PROJECT P. & L. 3rd Add.

Drainage Plan: ~~Diagram 2~~ P & L 3rd Addition

Re: S/D 80-39 - Preliminary plat of P and L 3rd Addition

Re: S/D 80-39 - Final plat of P and L 3rd Addition

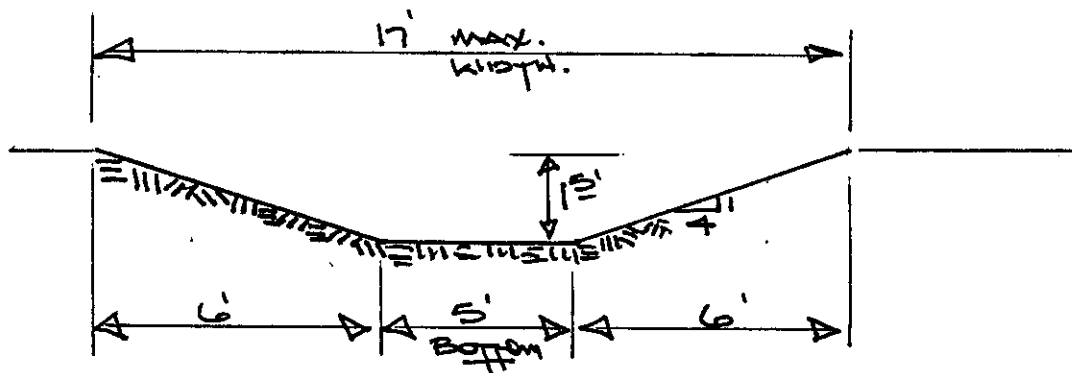
A PROPOSED DITCH SECTION BELOW WILL ADEQUATELY CONVEY THE MAJOR RUNOFF FROM AREA B. THE DITCH WILL REQUIRE ONLY A 17' WIDTH WITH 4:1 SIDE SLOPES INCLUDED, SO 20' IS ALSO ADEQUATE TO ACCOMMODATE THE DITCH SECTION. PROPOSED  $S = 0.40\%$ . ADEQUATE RIP-RAP NEEDS TO BE PLACED AT THE WEST END OF THE DITCH TO TRANSFER RUNOFF NORTH INTO THE LARGER DRAINAGE WAY WHICH LEADS TO 31<sup>ST</sup> ST. SO.

FLO CAPACITY = 50 CFS.

HOLYOKE CIRCLE

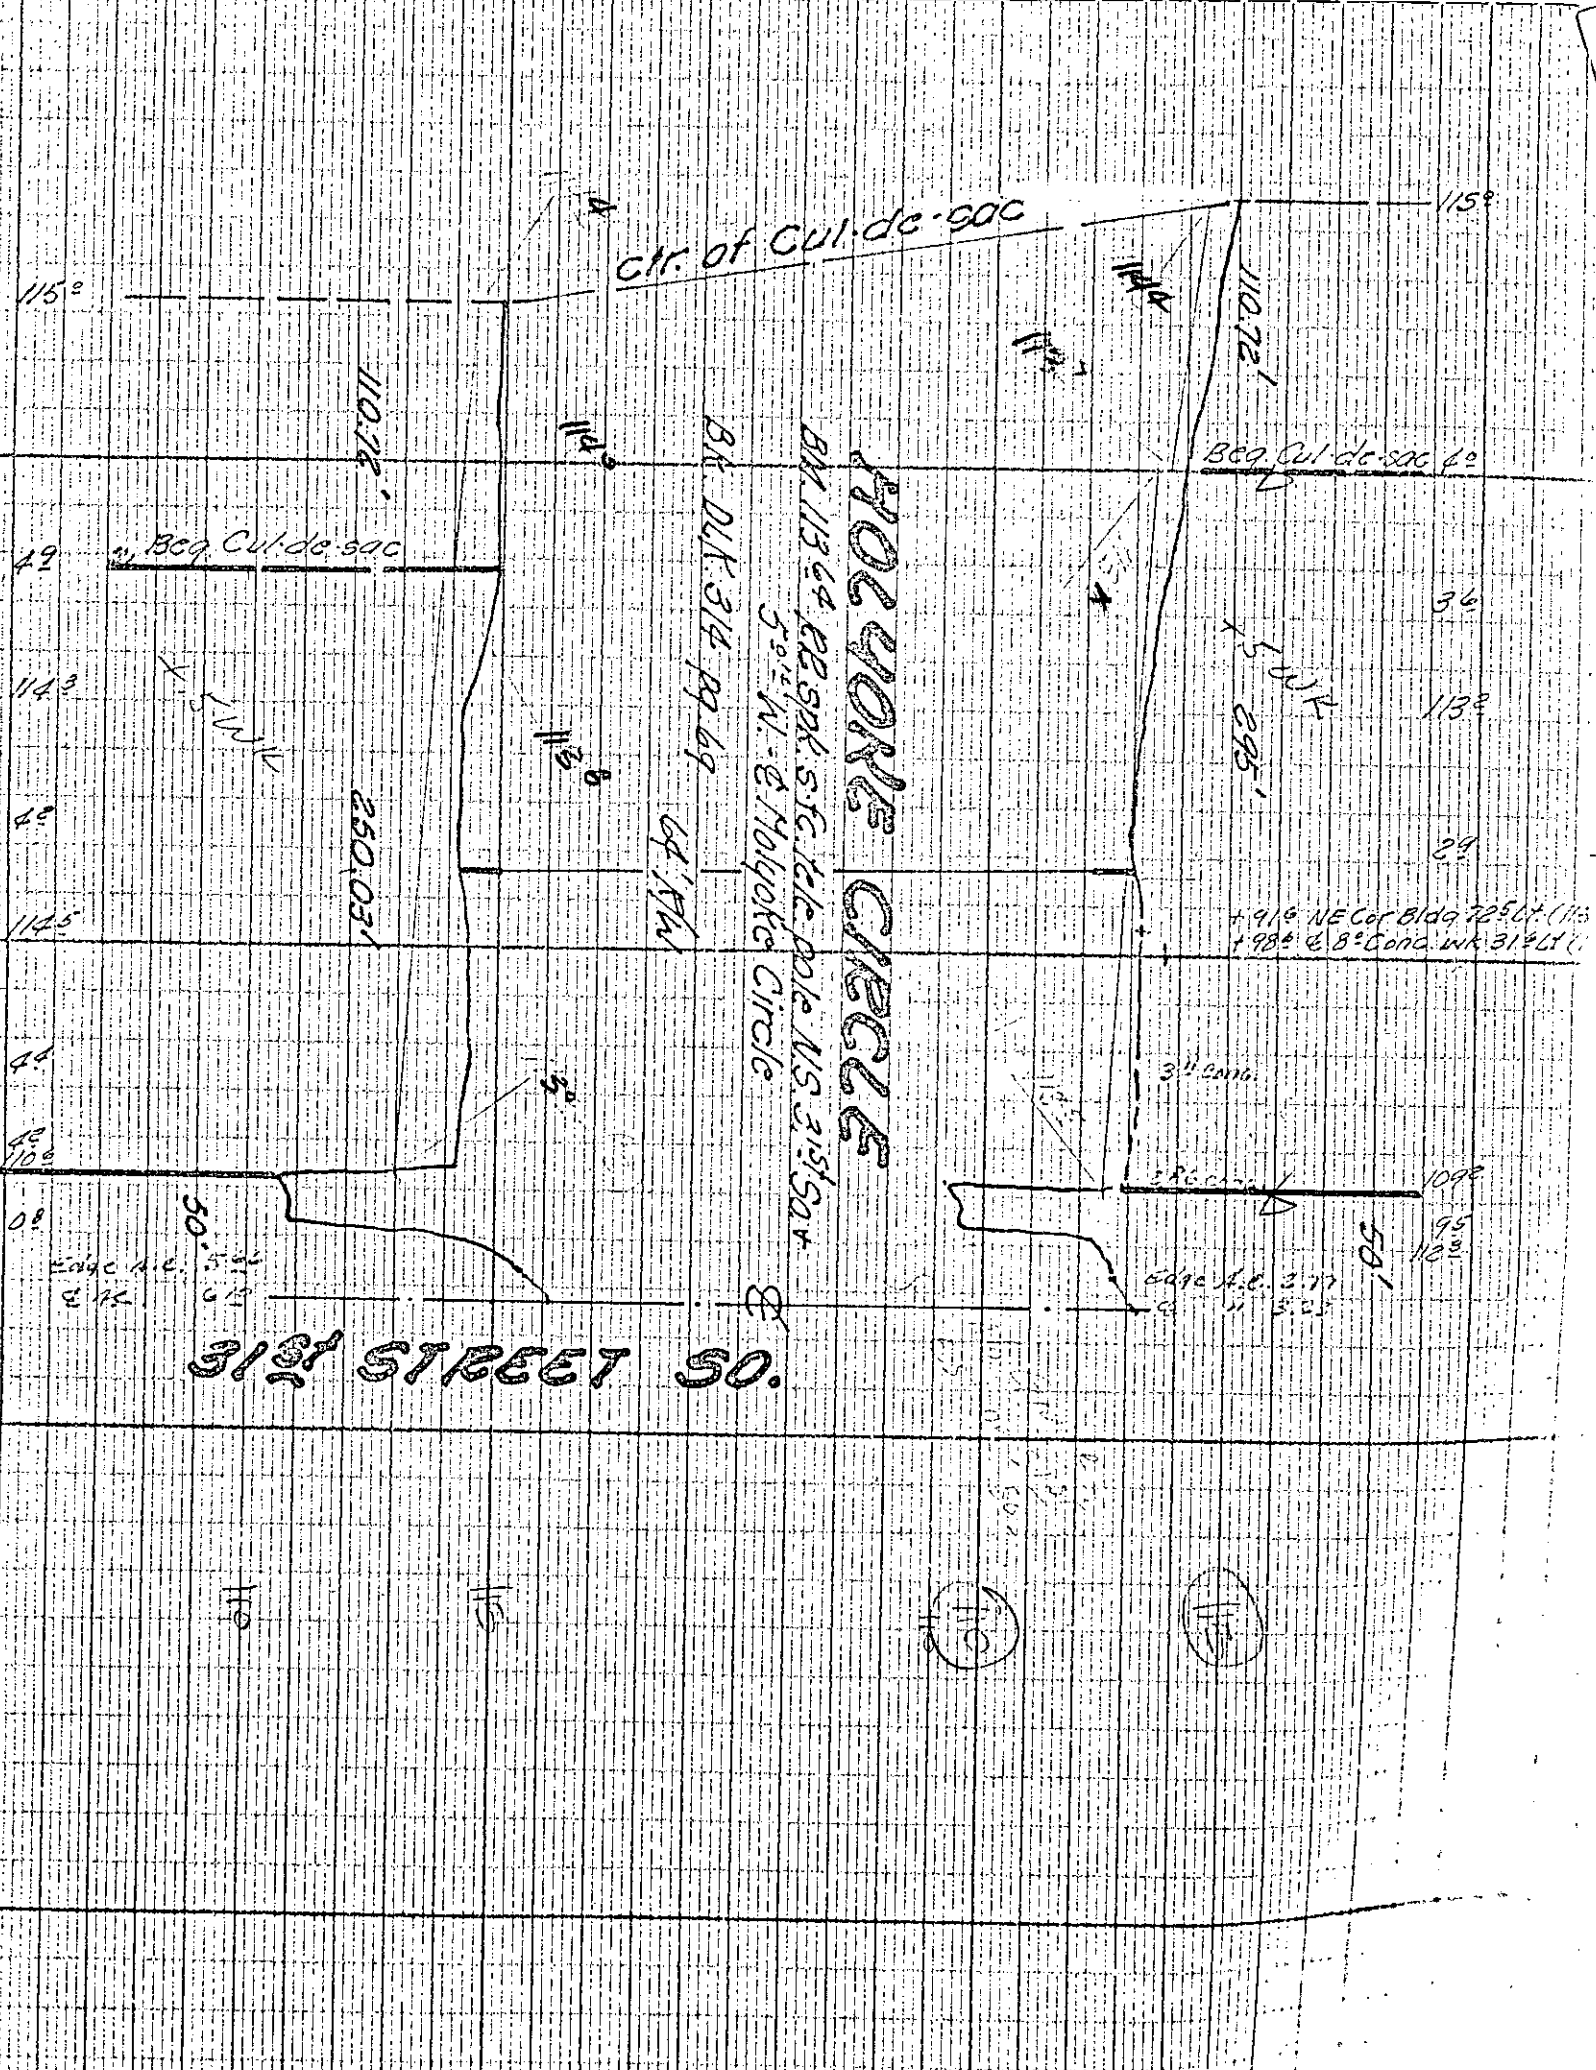
1. The drainage plan submitted does not show any street elevations, street grades and calculations showing quantity of runoff generated.
2. The drainage plan ~~also~~ shows storm runoff discharging into an arterial street: 31<sup>st</sup> Street South. At the present time the water could discharge into the ditch along 31<sup>st</sup> Street South; but in future when 31<sup>st</sup> ~~South~~ Street is constructed to City Standards, the water would flood 31<sup>st</sup> Street which is contrary to City Criteria.

4. ~~The drainage of the lot is~~ A survey of the ditch ~~shows that~~ along South line of 31<sup>st</sup> Street South shows that a number ~~of~~ <sup>of</sup> obstructions in the ditch (e.g. 18" ~~at~~ Cross Road Pipe instead of ~~the~~

a minimum 42" pipe equal to that located upstream) exist which will result in poor drainage <sup>in</sup> the subdivision.
